UNITED STATES PATENT AND TRADEMARK OFFICE

APPLICATION NO.	FILING DATE	FIRST NAMED INVENTOR	ATTORNEY DOCKET NO.	CONFIRMATION NO.
09/384,971	08/30/1999	MASAHIKO KUBOTA	35.C13752	8550

# Office Action Summary

## DETAILED ACTION

**FIG. 4**

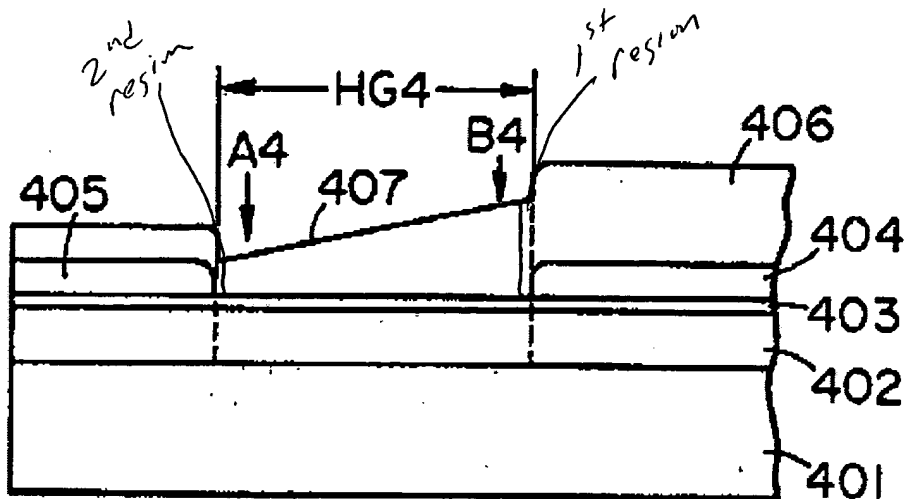
Applicant's argument that Shirato et al. does not teach a first region with a substantially uniform thickness along the direction connecting the electrodes and a second region with a substantially uniform thickness along the direction connecting the electrodes is not persuasive.

As illustrated above, Shirato et al. teaches a first region having a substantially uniform thickness along a direction connecting the electrodes and a second region having a substantially uniform thickness along a direction connecting the electrodes, wherein the second region is thinner than the first region. If one looks at small regions, then the thickness is substantially the same. Therefore, the claimed limitation is met.
